Work Order ID 99607

Item ID: 646.38127 Accept *N900040100* Setup Start *NS1*
 Revision ID: Stop *NS2*
 Item Name: Gusset Bracket
 Start Date: 5/24/13 Start Qty: 20.00 *20* Cust Item ID:
 Required Date: 5/24/13 Req'd Qty: 20.00 *20* Customer:
 Reference:

APICAL INDUSTRIES, INC.	ENGINEERING CHANGE NOTICE NO. 03697				SHEET 1 OF 1	
	DWG NO. 646.3800	REV: N/C	PREPARED BY B. PETERS	DATE: 11/14/12	EFFECT ON DWG <input type="checkbox"/> INC. <input checked="" type="checkbox"/> UNINC.	
	DWG TITLE: BRACKETS					
APPROVED BY: ENGR <i>[Signature]</i>		MFG <i>David Baker</i>	QC <i>[Signature]</i>	EFF: NEXT ORDER		
TRANSACTION CODES (TC): A-ADD C-CREATE R-REVISE D-DELETE		REASON: ADDED ALTERNATE MATERIAL.			ECR: D-12-006

SHEET 1, ZONE A2 IS:

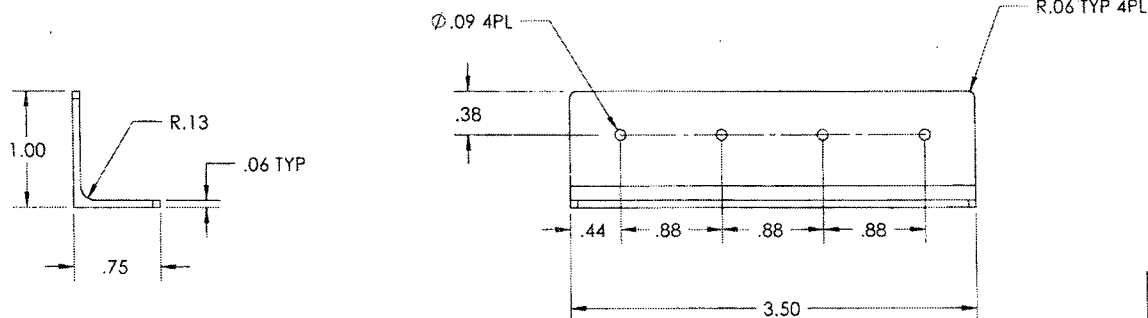
⚠ PRIMARY MATERIAL: 7075-T651 ALUMINUM PER AMS-QQ-A-250/12.
ALTERNATE MATERIAL: 7075-T6511 ALUMINUM PER AMS-QQ-A-200/11.
